Note

R 07/7410

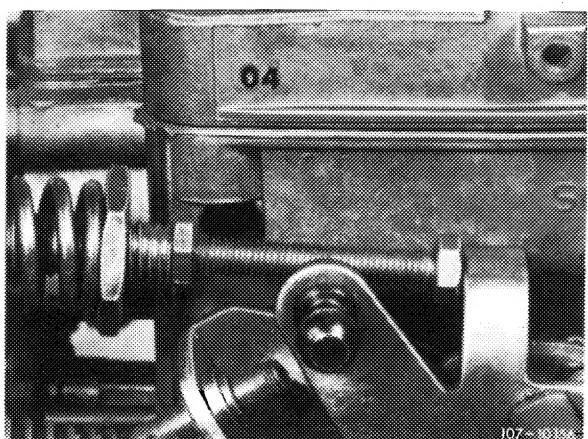
To prevent bypass faults (stage jump) from stage I to stage II, the bypass bores (arrow) are located 8 mm deeper under air valve starting January 1973 or starting carburetor cover code number "04", respectively. Subsequent installation is generally possible.

- 1 Remove carburetor cover, remove air valves of stage II.
- 2 Close former bypass bores by riveting with aluminum plugs of 2 mm dia. and, in similar alignment underneath, 8 mm above carburetor cover parting surface, drill a new bypass bore 2 mm dia. for each stage.

3 Blow through riser pipes (158) for stage II, install air valves, while paying attention to easy operation of valves.

4 Mount carburetor cover.
